# ADDENDUM: Great South Road Intersection

## GREAT SOUTH ROAD INTERSECTION

The Urban and Landscape Design Framework (ULDF) was finalised in November 2016. As a progression of the work to date, the design of the EWL/Great South Road/Sylvia Park Road intersection has been revised from the at grade design originally proposed, to a grade separated design. Grade separation of the east west through movements at this intersection will provide improved reliability and future resilience. While the ULDF continues to be the umbrella document guiding the urban and landscape design outcomes for the Project, this addendum is provided to address sector-specific design drivers and outcomes resulting from the revised intersection design. The following guidance has been developed by the urban and landscape team working with other technical specialists, in the same way as for the previous intersection design, to outline the expected level of amenity and design quality. This addendum specifically relates to Sectors 3 (Anns Creek) and 4 (Sylvia Park Road) of the EWL alignment and replaces the sector specific outcomes sections (Section 5.3 and 5.4 respectively) of the main ULDF for these sectors. Supp

Figure 43 (revised). Sector 3: Anns Creek: plan

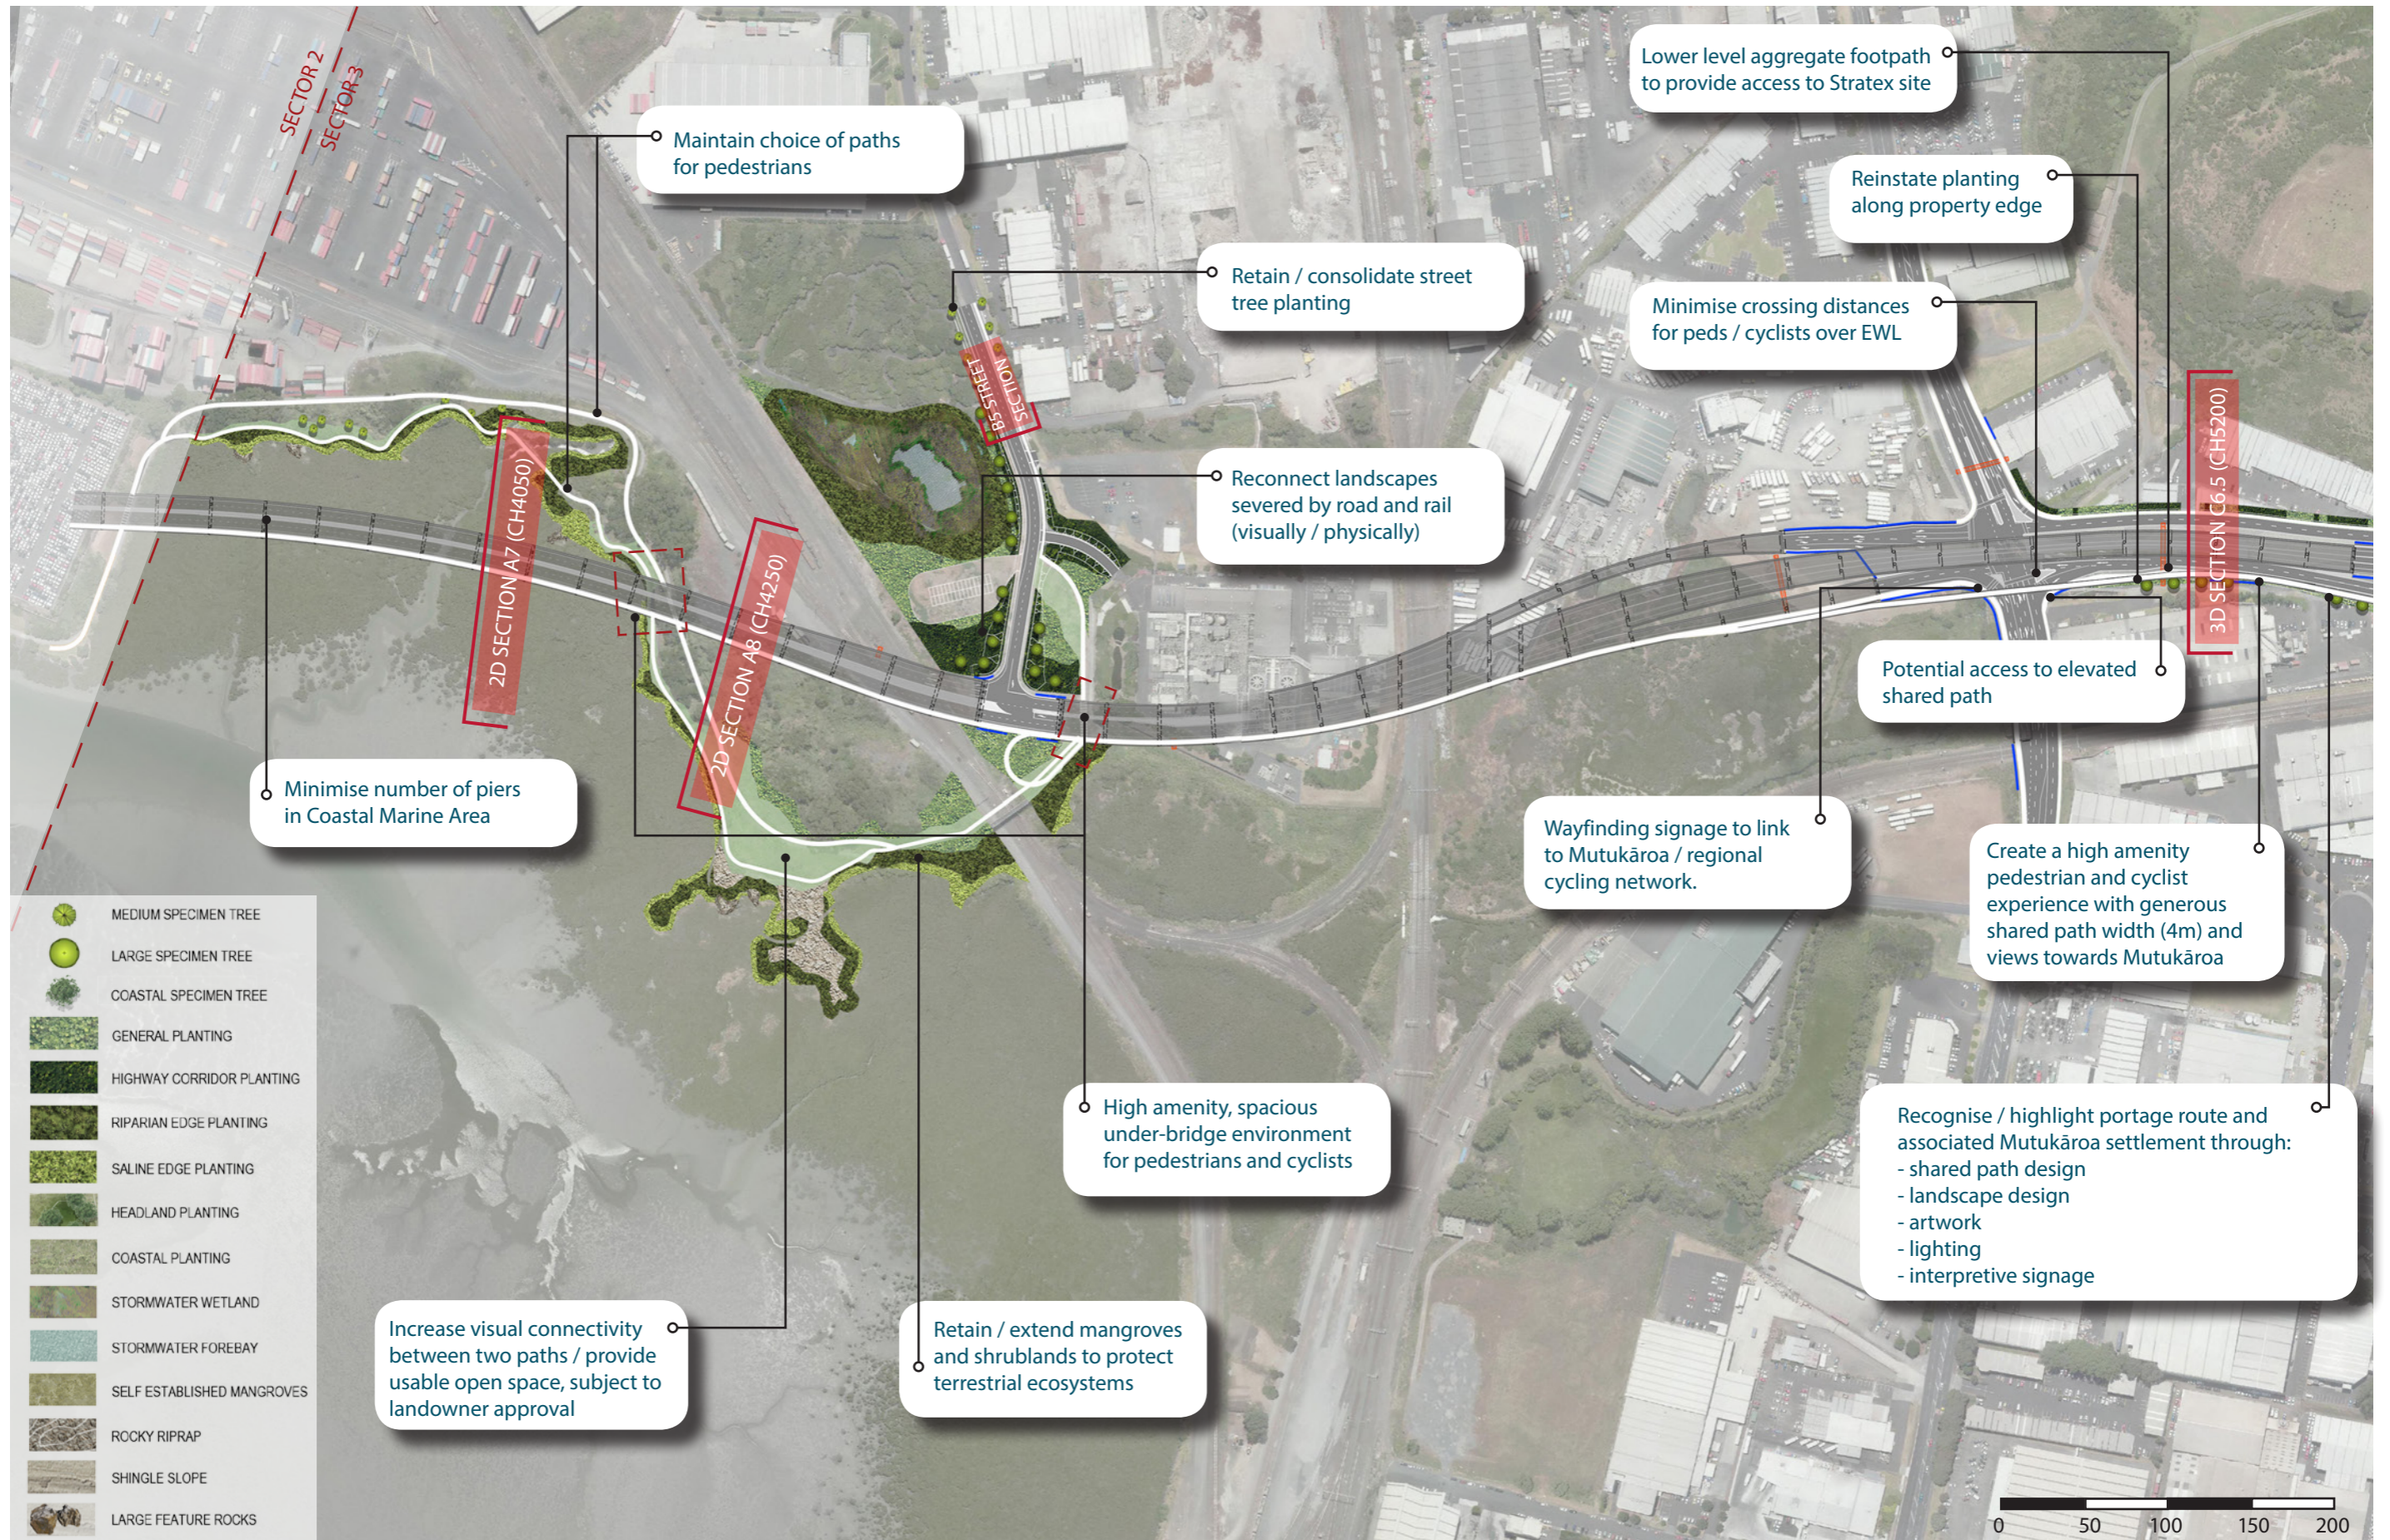
With the revised intersection design, the design team believes that the best way to achieve a consistent pedestrian and cycle experience whilst highlighting the Karetu portage route is through provision of a clearly delineated shared path where EWL is on structure in both Sectors 3 and 4. The images on this page illustrate relevant design approaches and design quality that are sought for this important linear connection.

- Provide new, elevated views for users of EWL towards Mutukāroa
- Design the shared path ("Karetu Portage path") in this location to be the dominant visual feature of the streetscape. Matters to consider include:

- Consistency of design with the Karetu Portage path along Sylvia Park Road, including continuity in structural edge treatment
  - Providing an elevated shared path for pedestrians and cyclists where EWL is elevated on structure in this area (between (approximately) Anns Creek and the existing Stratex site)

- Retaining a sense of elevation from the road for pedestrians and cyclists even in sections where EWL is no longer on structure (for example the shared path might sit slightly above grade)

- Utilising lighting, landscape and hardscape treatment as a feature
- Design the shared path and associated landscape treatment to allow for long clear sightlines for shared path users.
